Addendum 2
Solicitation 24-99842
Upper Lakeside Water Interconnect – Phase 1

ADDENDUM #2

Project Description City of Duluth
Upper Lakeside Zone Water Main Interconnect – Phase 1

revision	
△ REV 1	11/27/24
Proj:	24-525
Date:	11/13/24
Drawn:	DRH
Checked:	TTP
SITE RESTORATION	
Sheet Title	
Sheet Number	24

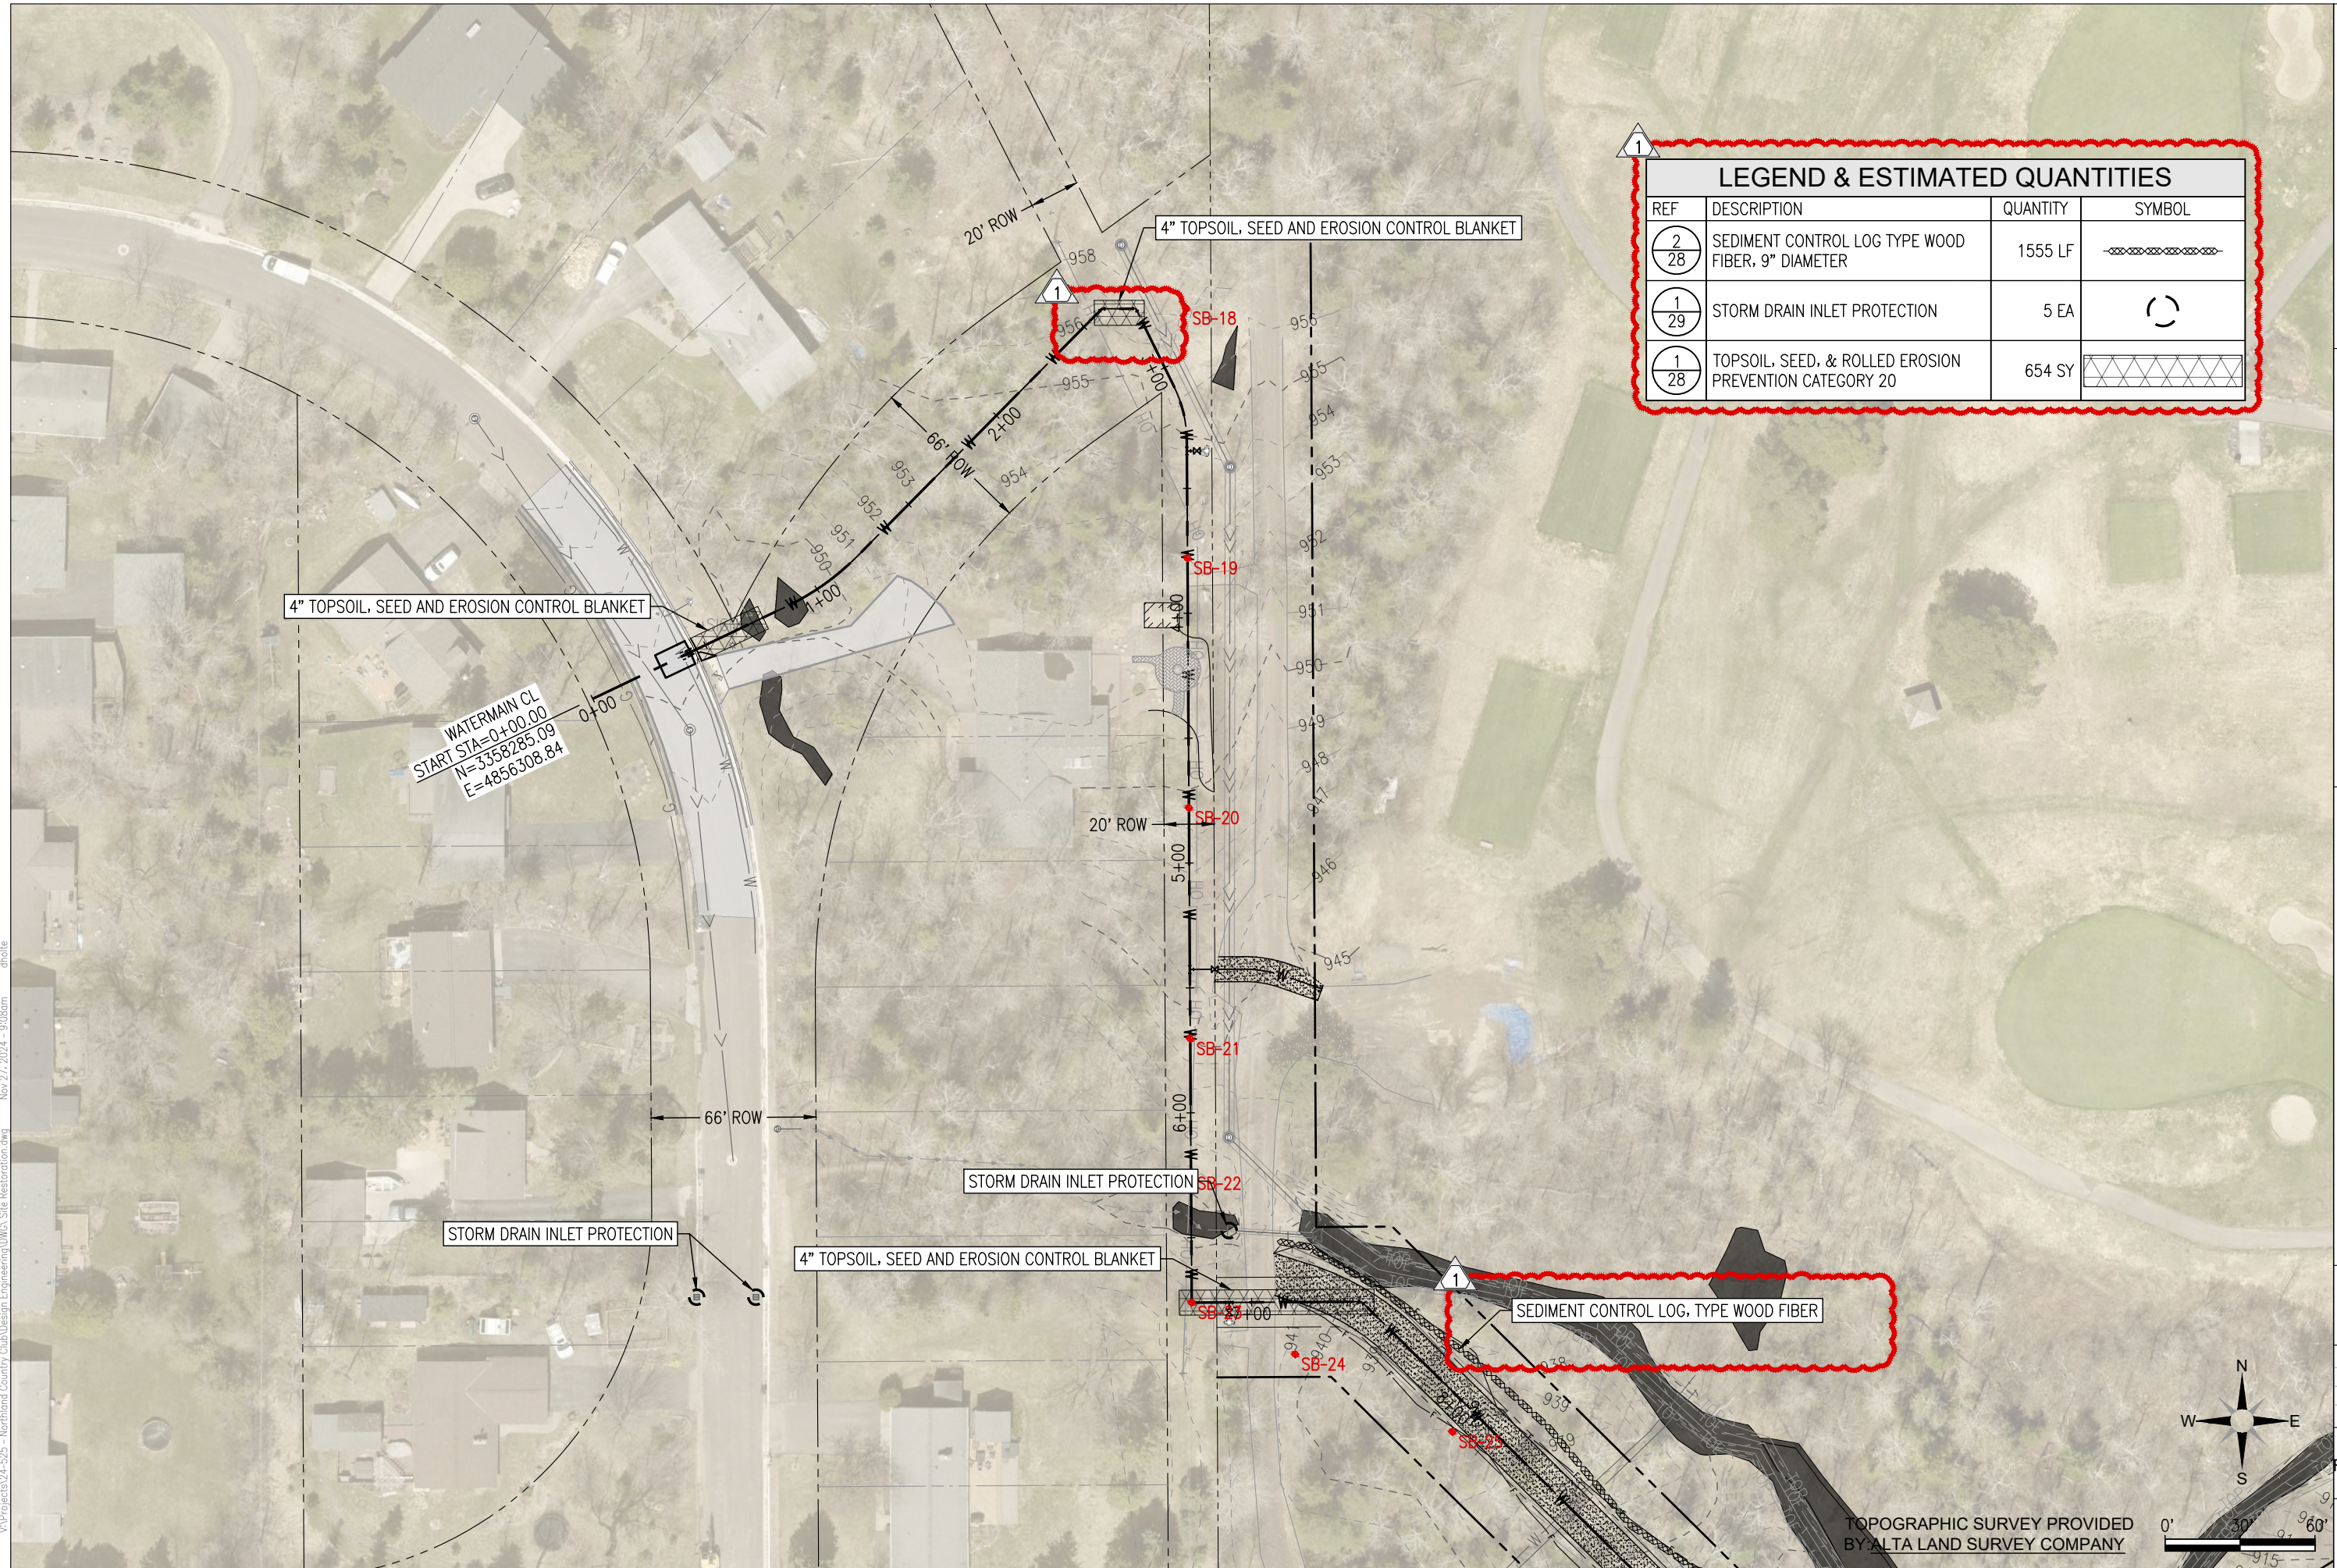
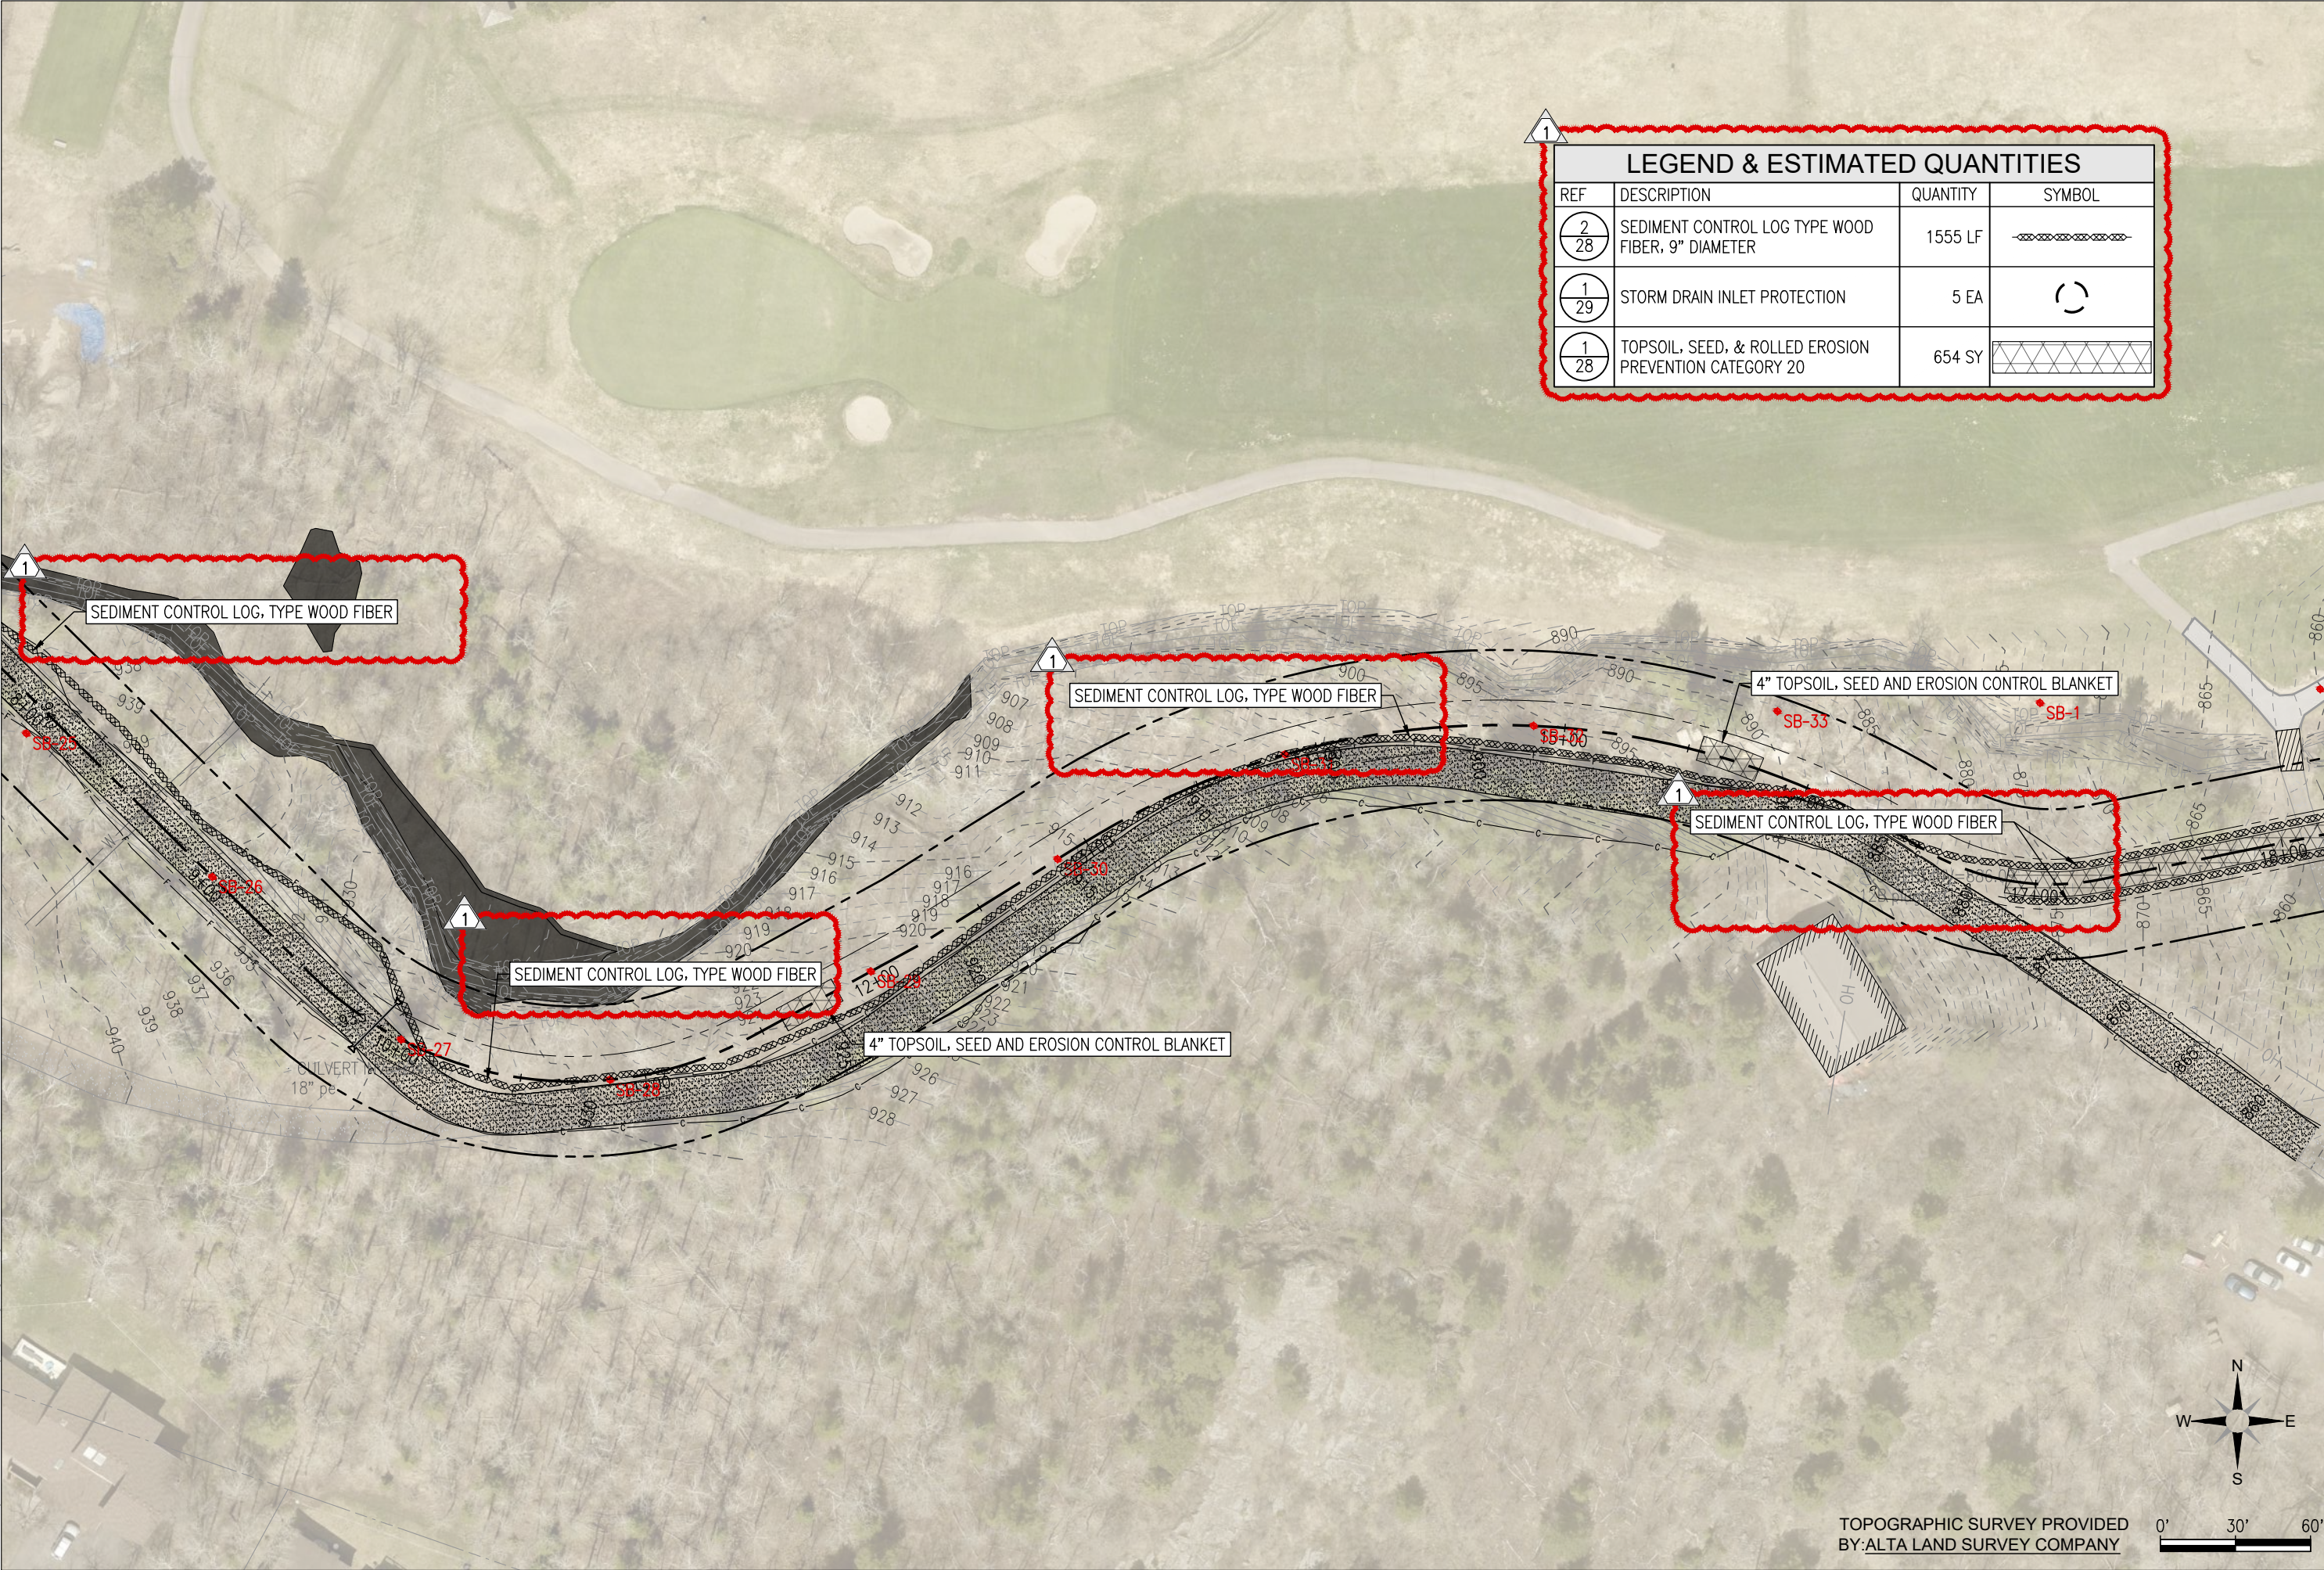
8. Sheets 23-26 SITE RESTORATION:
 - a. Segments of silt fence have been removed at boring pit locations as it won't be necessary.
 - b. Other project silt fence has been switched to sediment control log type wood fiber (9" diameter).
